BEFORE THE PANEL PURSUANT TO THE FAST-TRACK APPROVALS ACT 2024**IN THE MATTER**

of an application made under the Fast-Track Approvals Act 2024 by RCL Homestead Bay Limited.

RESPONSE TO WRITTEN COMMENTS**RCL HOMESTEAD BAY LIMITED****4 NOVEMBER 2025**

Figure 4-14: Outlets 5, 6 and 7 each drain to an existing culvert under Chief Reko Rd - Pre and Post Development Catchments showing reduction in catchment area

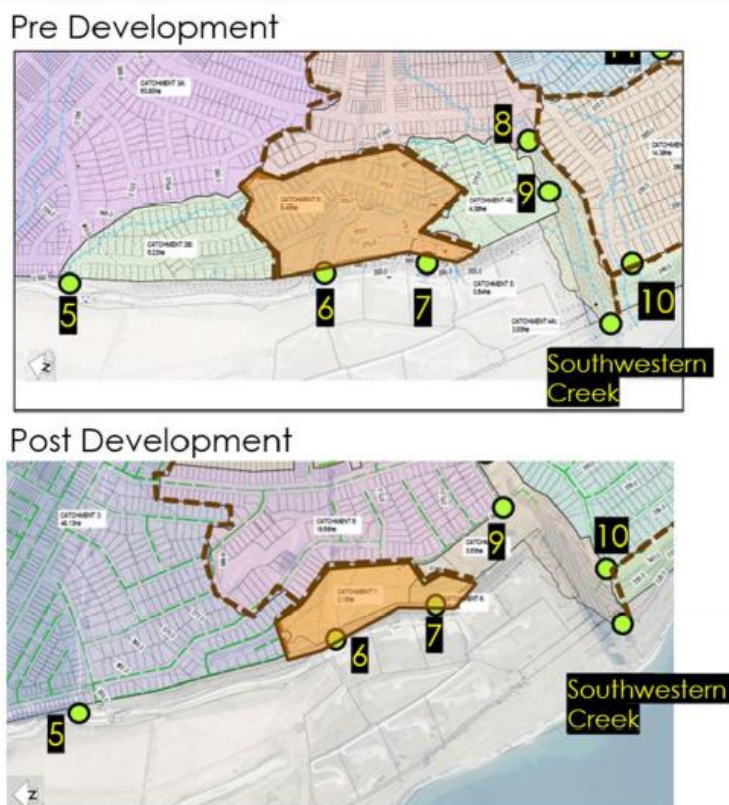
161. The Homestead Bay Residents Society Incorporated raised concerns that the stormwater design does not take into account the smaller gully to the north of their properties. However, the proposal does take into account the gully the submission refers to. Drainage from the area of the existing gully that is to be developed as housing will be to a new pipe network, diverted away from the downstream neighbouring property in Nathaniel Place. Section 4.5.3 of the Stantec “Infrastructure Feasibility Report” (Appendix B) should be referred to for information on this.

162. The drainage gully identified in the submission of Homestead Bay Residents Association is shown as Outlet 6 in the Stantec Report. This report includes the following figures showing pre- and post-development catchments and Table 4.4 in the Stantec report shows that existing flows will be reduced by up to 50% following development.

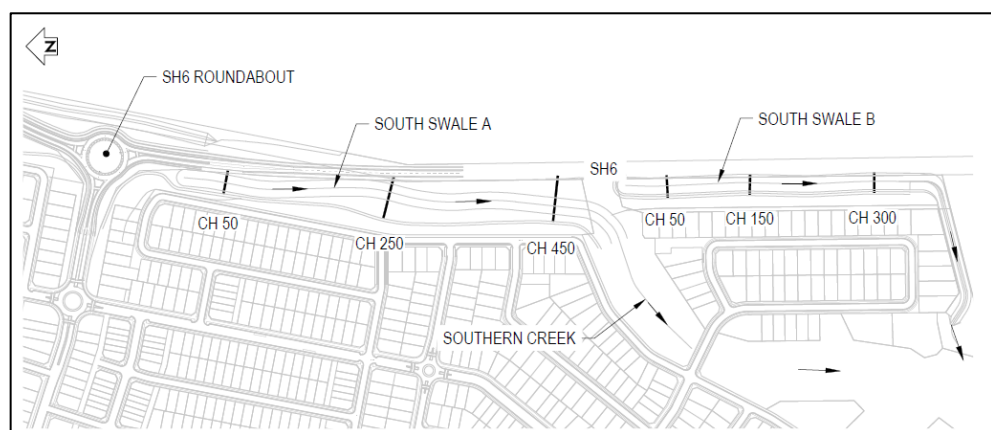
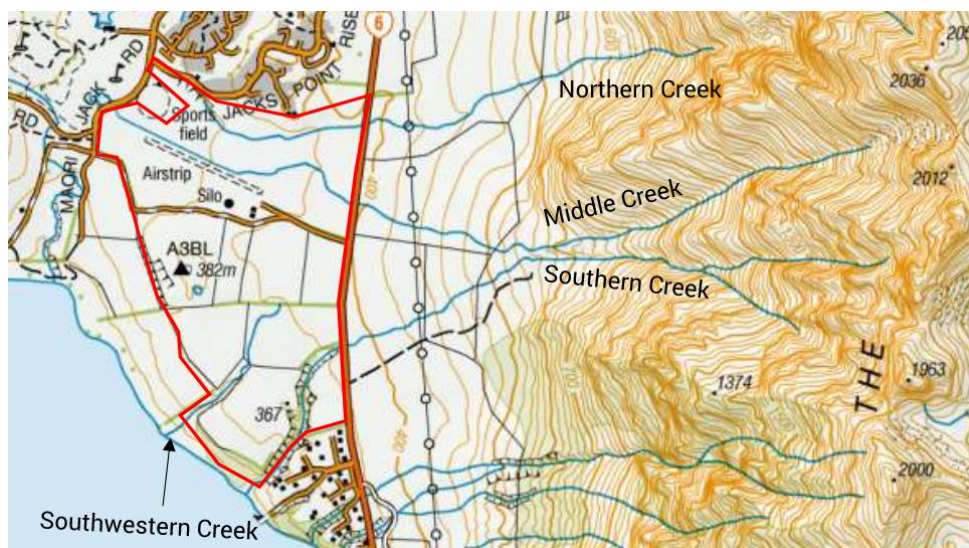
165. NZTA have requested that the height of the bund and the rate of stormwater discharge through the diversion channels along the SH6 frontage of the

subject site be designed and constructed to ensure 250mm of freeboard is maintained at all times with the edge of the SH6 pavement formation and there is no standing water within a 1m horizontal offset to minimise the risk of pavement saturation. Stantec have provided the following confirmation that this can be achieved:

- The typical section the submitter has used is for a 100yearARI event with snow and debris. The water level shown would only occur briefly and rarely and is unlikely to saturate the pavement.
- Further sections at actual locations are shown in Stantec drawings 310104425-00-000-C0274 to C0275
- Six cross sections along Swale A and B (three from each swale) have been created to assist in responding to this RFI. The location of each section can be seen below.

- Multiple ARI events were assessed and are listed below. The peak runoff information was received from the Geosolve Natural Hazard report (Appendix B) and via email from Geosolve for the ARI1.58 event. The flows shown assume that Middle Creek and Southern Creek have combined which is very conservative (see figure below).
 - ARI 1.58
 - 6.3m³/s
 - ARI 20
 - 21.4m³/s
 - ARI 100
 - 37.8m³/s
 - ARI 100 with snow melt
 - 43.4m³/s

- ARI 100 debris flow
 - 51.7m³/s

- Each cross section was assessed using the software package Flow Master which determined the flow depth at each cross section for each ARI event. The freeboard was then calculated at each section and can be seen in the below table. This freeboard is from the edge of to the top of the water level. All cross sections therefore provide more than 250mm freeboard up to the 1 in 20year event. This is an appropriate level of freeboard and the pavement will only be wetted for a short period in an undefined event between ARI 20 and ARI 100. The freeboard will be more than shown due the conservative approach of assuming that Middle Creek and Southern Creek have combined for all ARI events.
